Final Technical Plan
July 1988

LITIGATION TECHNICAL SUPPORT AND SERVICES

Rocky Mountain Arsenal

Offpost Remedial Investigation/Feasibility Study

Figure A-3
CHLORINATED PESTICIDE ASSESSMENT
RMA OFFPOST FIRST QUARTER SAMPLING
OF WELLS

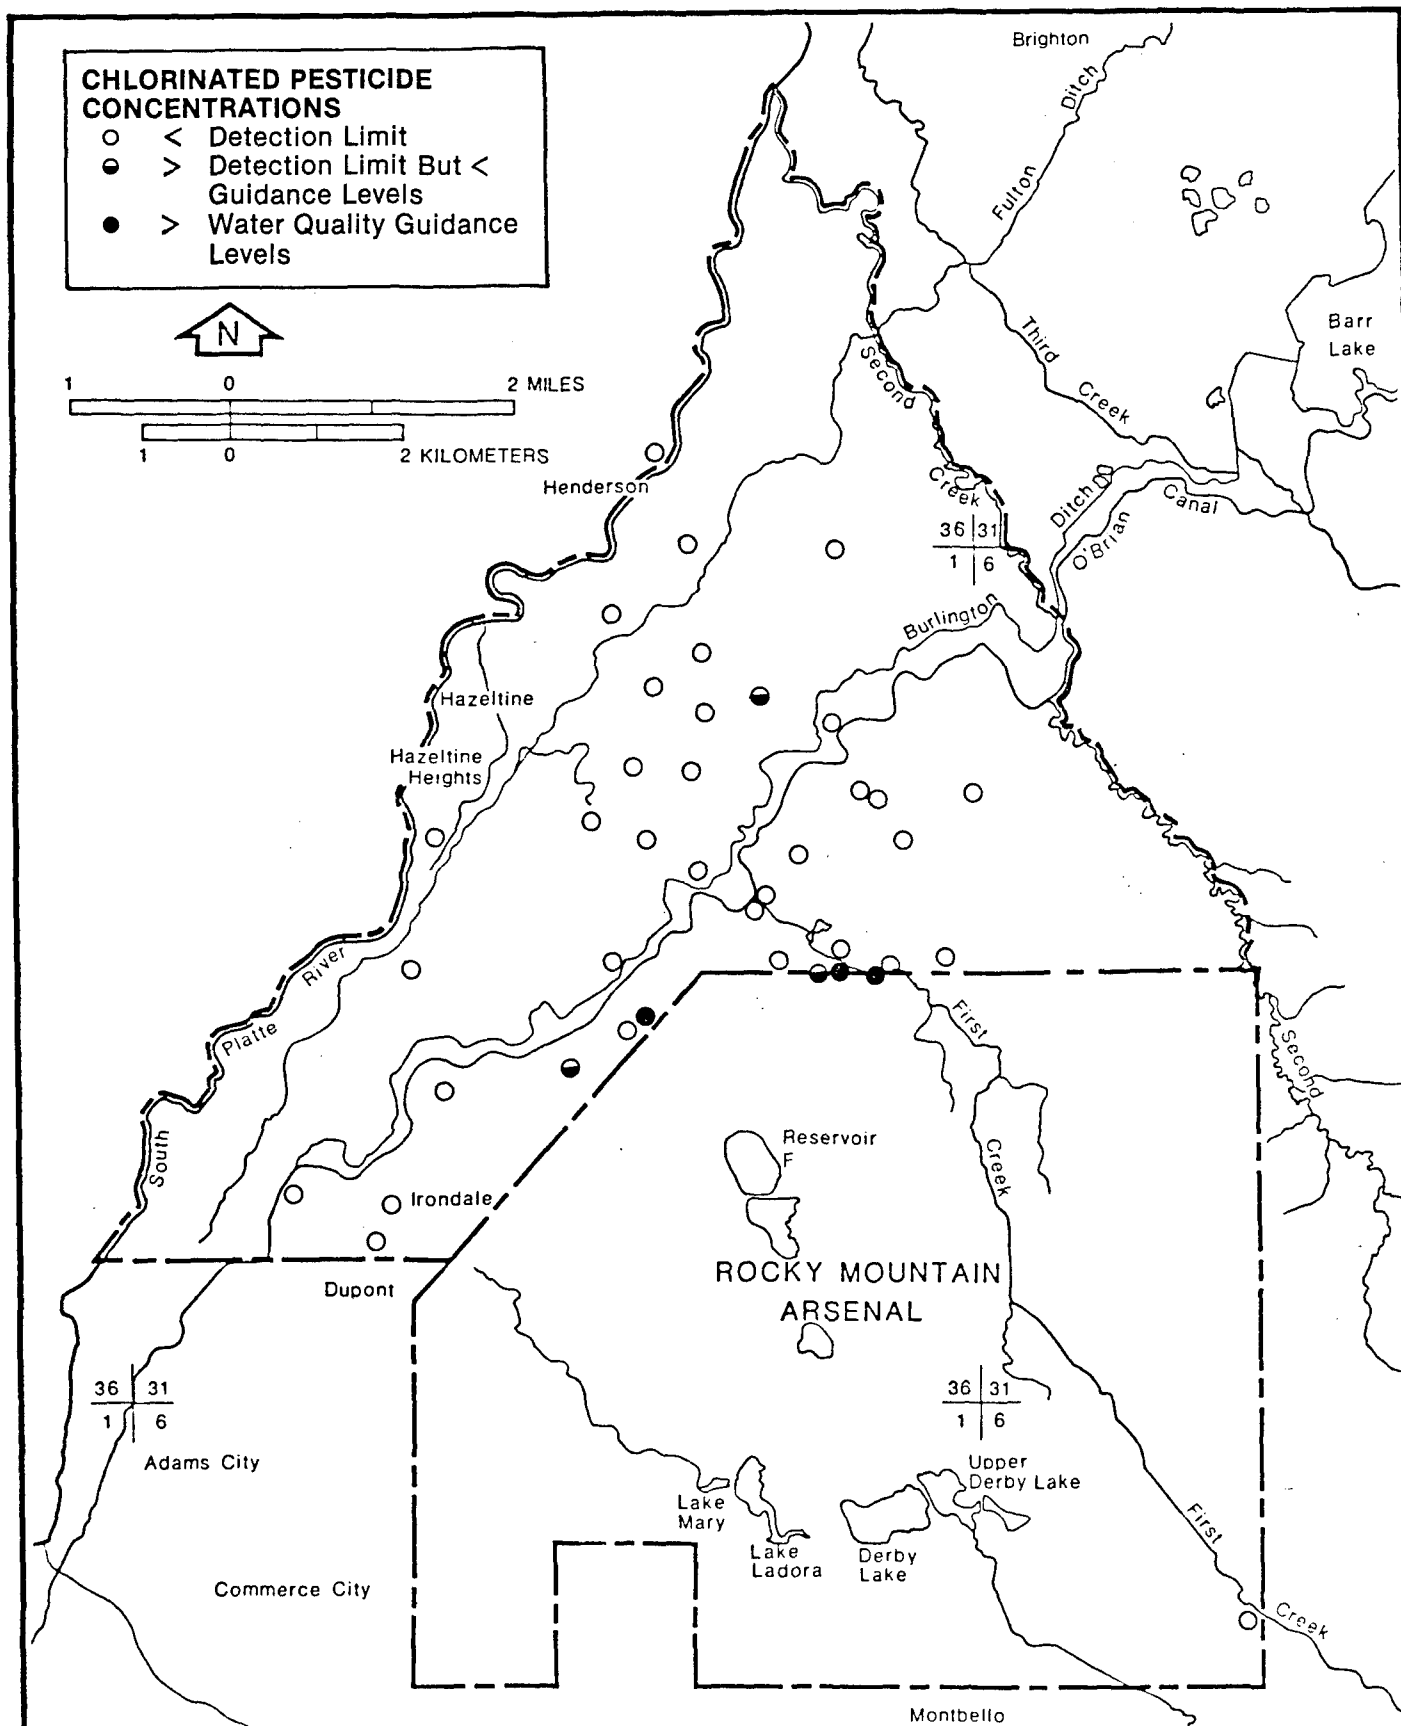
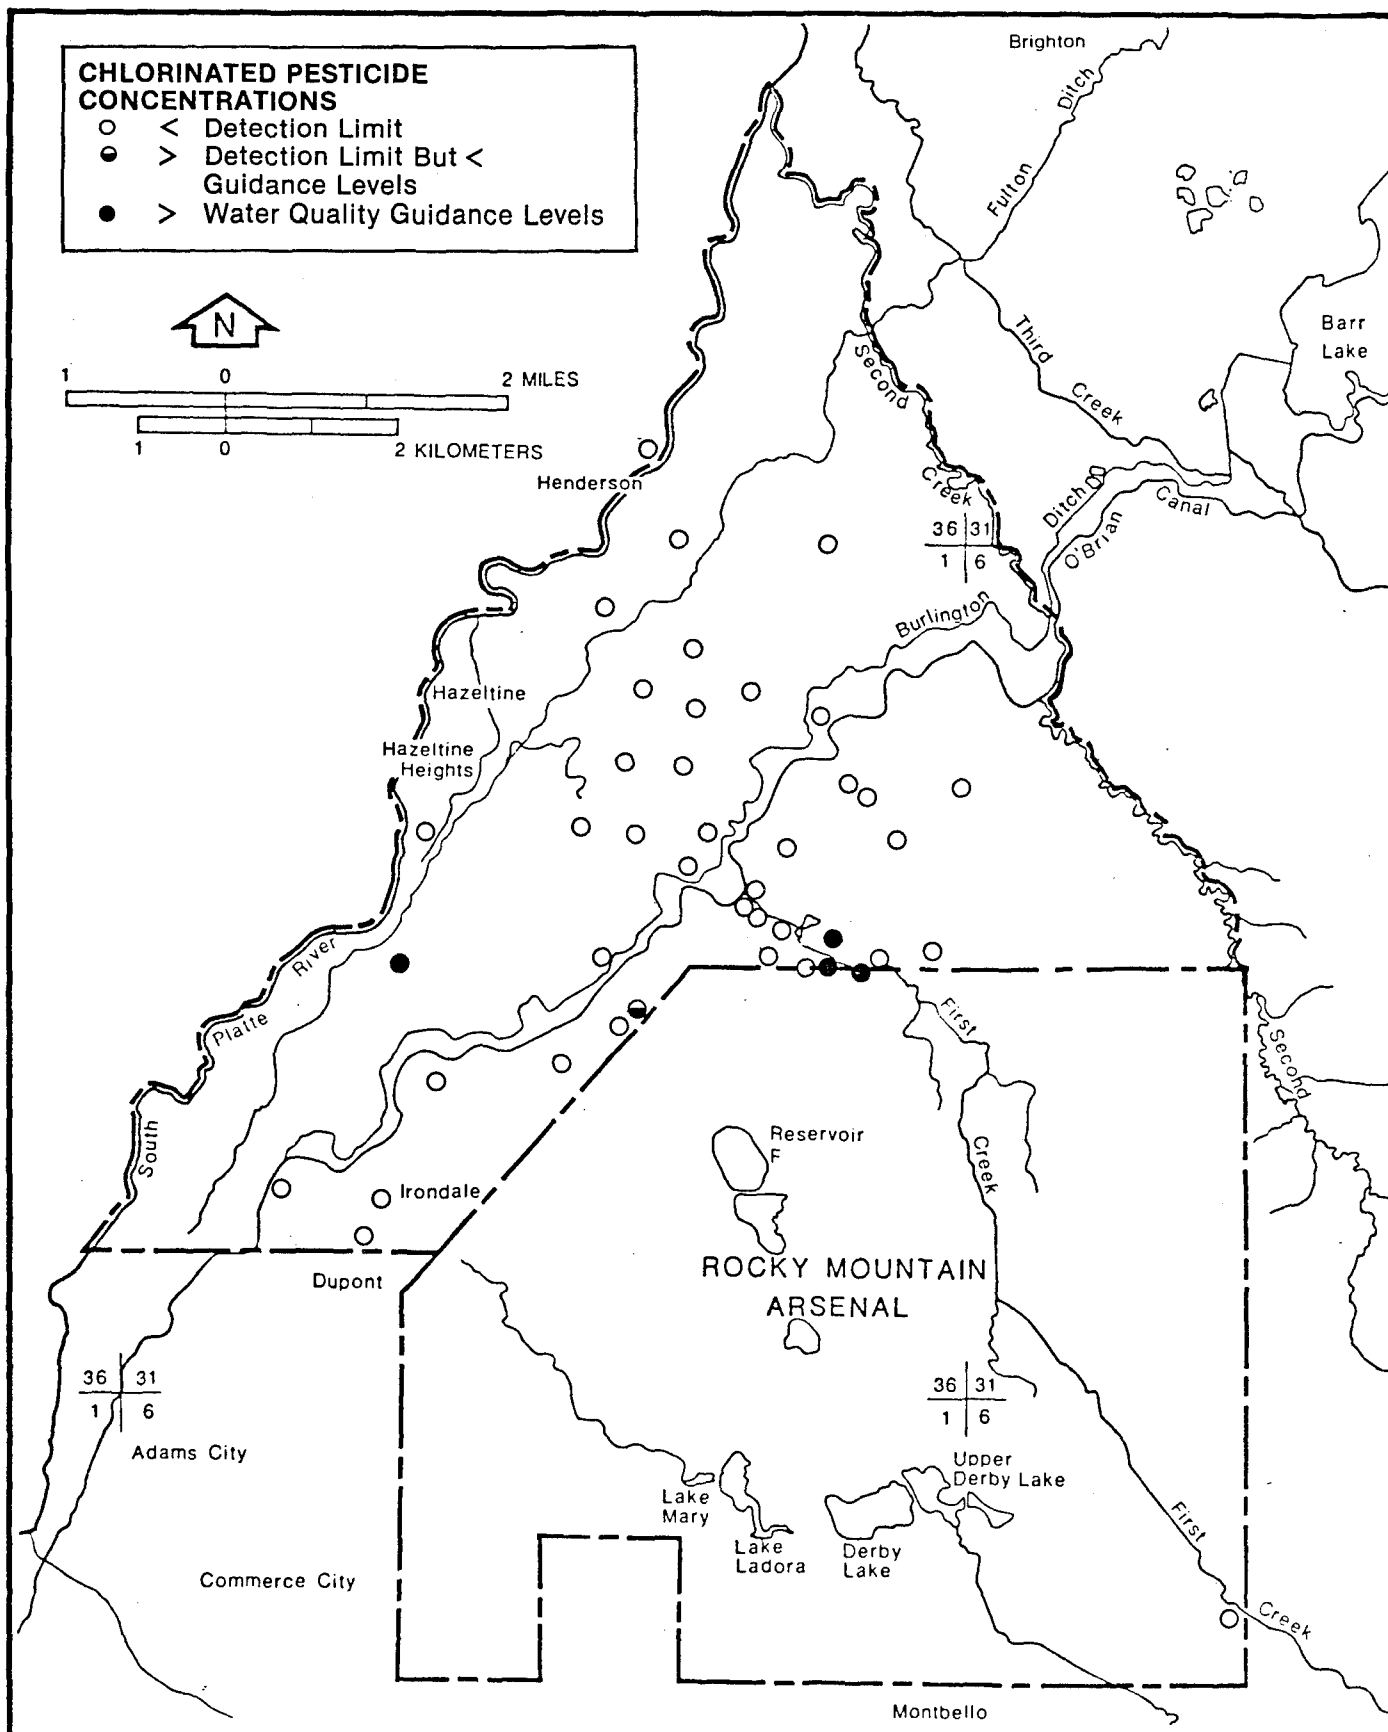
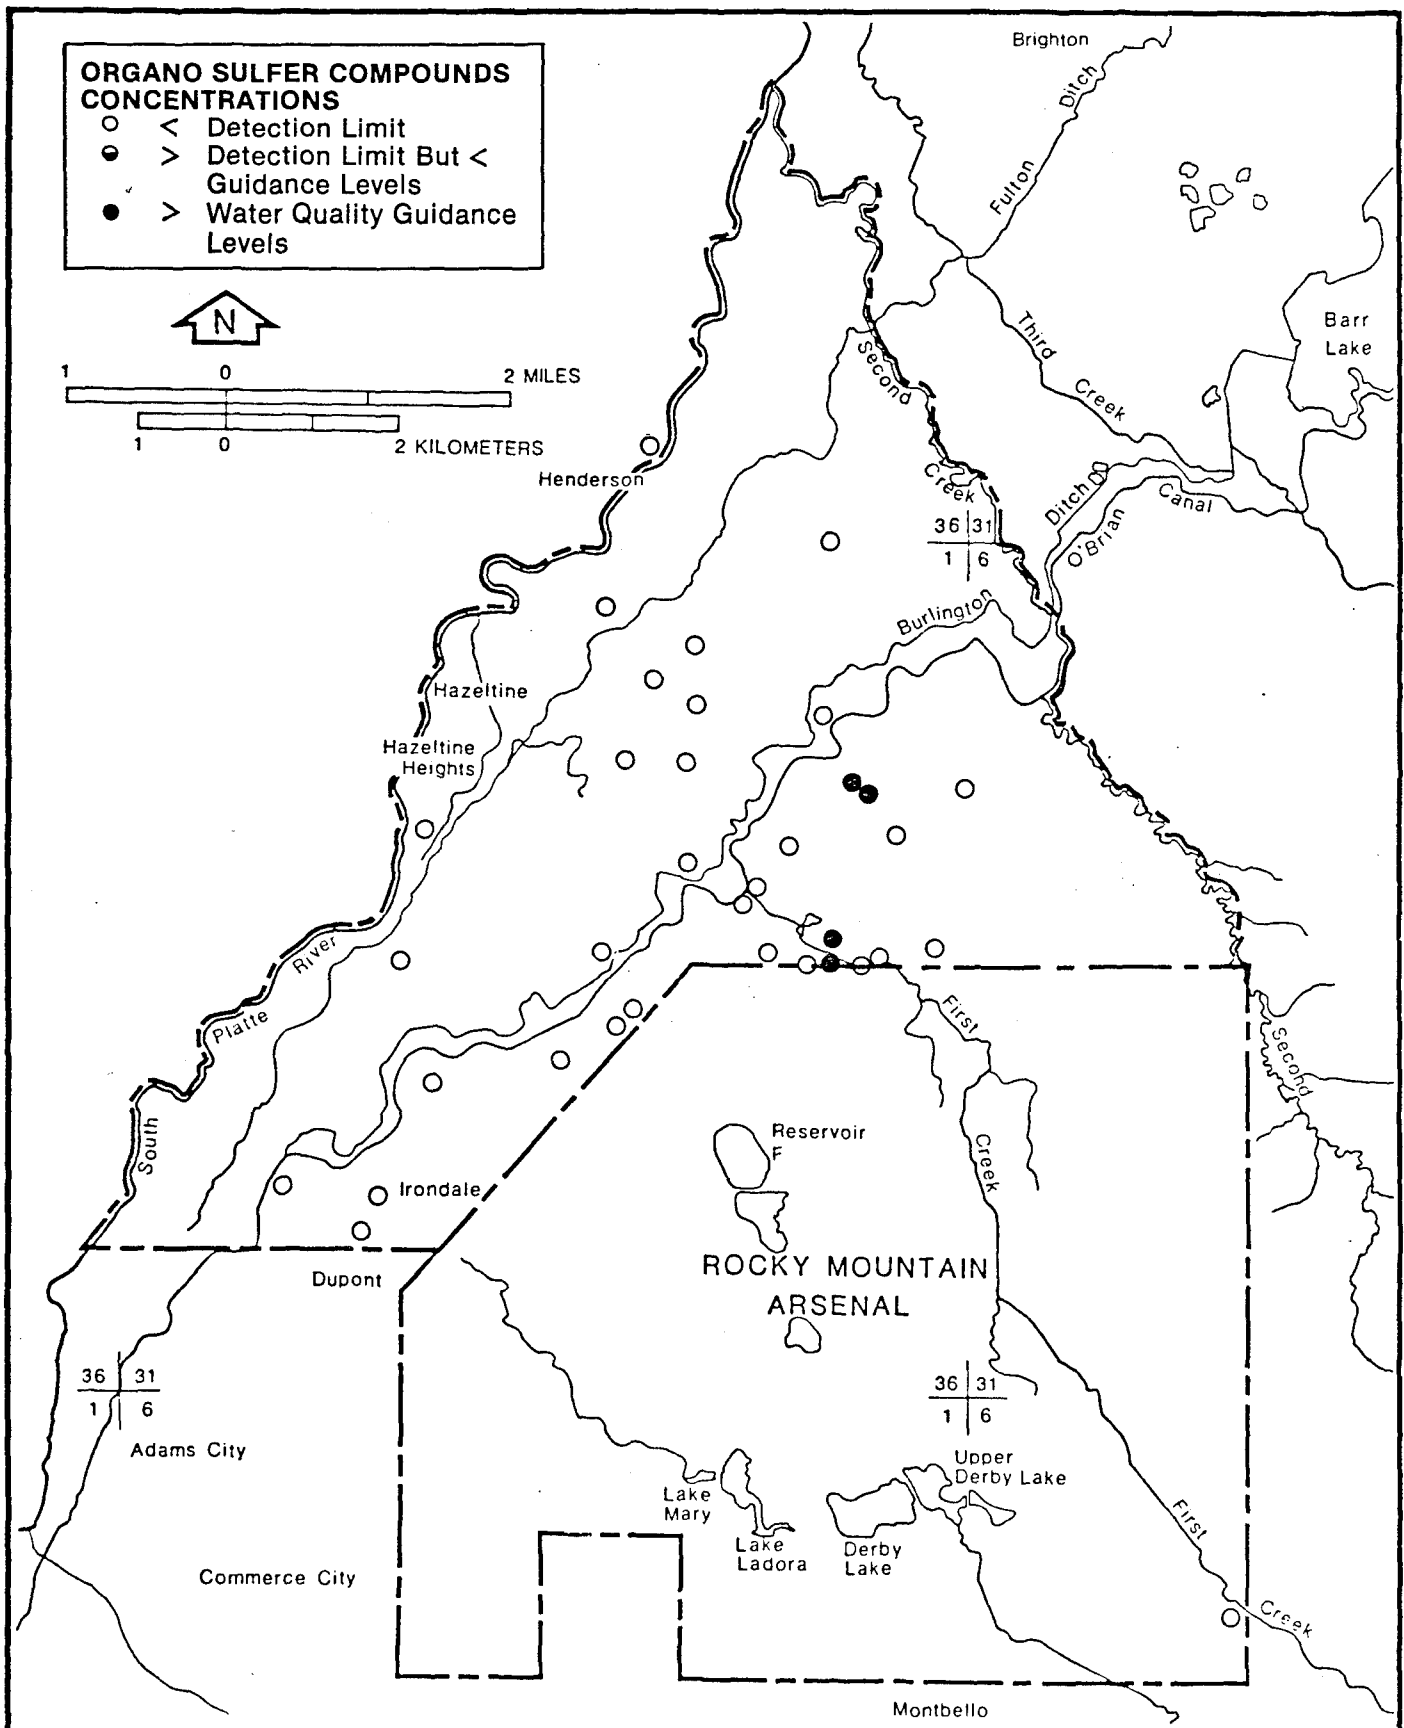
Comment 4:
Figure 1.4-1,
1.4-2, A-1 to A-9
